PLANNING COMMITTEE

Schedule of Committee Updates/Additional Representations

181583 - PROPOSED NEW HEALTH CENTRE (USE CLASS D1) INCLUDING ANCILLARY PHARMACY (USE CLASS A1), ACCESS, PARKING, LANDSCAPING AND ASSOCIATED WORKS AT LAND FRONTING STATION APPROACH (CITY LINK ROAD), HEREFORD

182314 - SUMMARY DESCRIPTION (FOR FULL DESCRIPTION SEE APPLICATION FORM AND PLANNING CASE STATEMENT): • PROPOSED NEW FIELD ACCESSES • PROPOSED MAINTENANCE TRACKS TO SERVE SOUTHERN LINK ROAD (APPLICATION 151314) AT MULTIPLE PARCELS OF AGRICULTURAL LAND, SOUTHERN LINK ROAD CORRIDOR (151314) A465 - A49, HEREFORDSHIRE

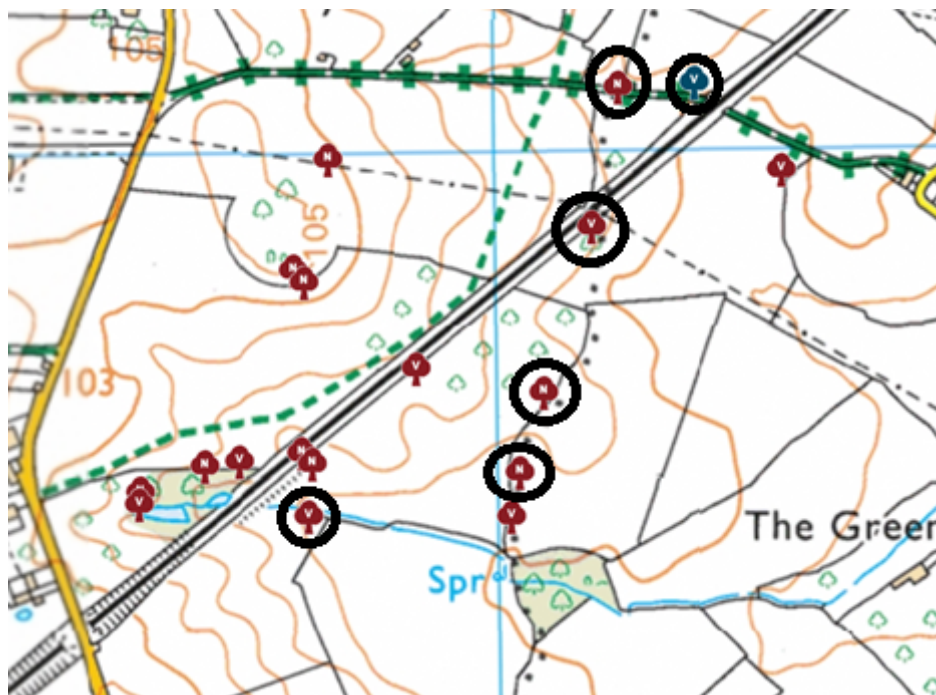
The Woodland Trust **objects** to this application on the basis of damage and potential future loss of a number of veteran trees. Many of these trees are designated on the Ancient Tree Inventory (ATI) with the following details:

These trees can be identified on the Ancient Tree Inventory via the links I have included above. If mapped against the proposed plans these trees can be identified, I have circled them below for you.

While the proposals do not require the removal of any veteran trees, there are elements of the application that would encroach within the canopies and root protection areas (RPAs) of these specimens, specifically temporary haul route alignments and the realignment of a cycle track and its associated fence line. Development within the RPAs and/or canopy of a veteran tree can result in adverse impacts on the tree by damaging the tree's root system through soil compaction and direct root damage, as well as bringing the tree in to a more public setting thereby making it a potential hazard and affecting its long-term retention.

In summary, the Woodland Trust **objects** to this application on the basis of damage to a number of veteran and notable trees. The proposed development would feature elements that encroach within their canopies/RPAs resulting in damage and threatening their long-term retention. It is apparent that the applicant has not given appropriate consideration to the veteran trees, particularly as they have used RPAs measured at 12 times the stem diameter, rather than the 15 times diameter recommended by Natural England where veteran trees are concerned.

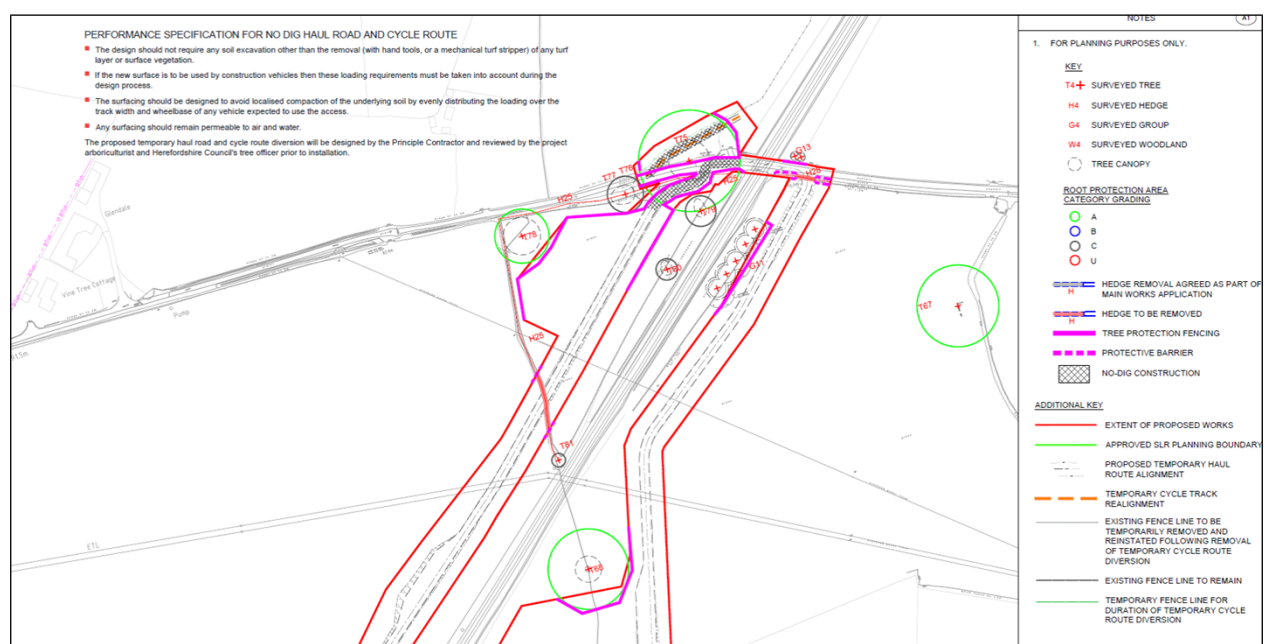
As members will see from the above correspondence, the Woodland Trust has raised concern about the assessment and impact on a number of trees affected by the temporary Haul route and temporary cycle route.

The Council's Tree Officer has very recently visited the site and confirmed that, in his opinion T75 that lies adjacent to the existing bridleway is a Veteran tree. Given the tree's proximity to the existing metalled bridleway (that would be used as the haul route), officers would accept that the mitigation proposed is acceptable. However, as a precaution, and in respect of the embankment required to exit the field onto the bridleway, a condition that includes the submission of a method statement is suggested. In addition, this condition will look at the other trees noted, their route protection areas and method statements for any works / storage within or adjacent to the route protection areas of the trees.

Given the comments received, officers would take a precautionary approach, and advise that it is not possible to confirm, without doubt, that the proposals would not result in the loss or deterioration of the veteran tree as an irreplaceable habitat. The NPPF directs that development should be refused, unless there are wholly exceptional reasons and a suitable compensation strategy exists.

Prior to commencement of any development detailed on drawing number – 3512983BP-WSP-ZO-XX-DR-T-00003-P04 Sheet 3 - a detailed Tree Protection and Mitigation plan shall be submitted to and approved in writing by the Local Planning Authority that shall include, but not be restricted to:

- Accurate plans showing the Root Protection Area
- Construction method statement for both the temporary Haul Road and cycleway
- Mechanism and details of monitoring for any impacts on trees during construction phase
- Detailed method statement for the reinstatement of land post construction phase
- Mechanism and details of monitoring for any impact on trees post construction phase
- Details of storage area for soil and method statement for soil storage within or adjacent to the Root Protection Areas.
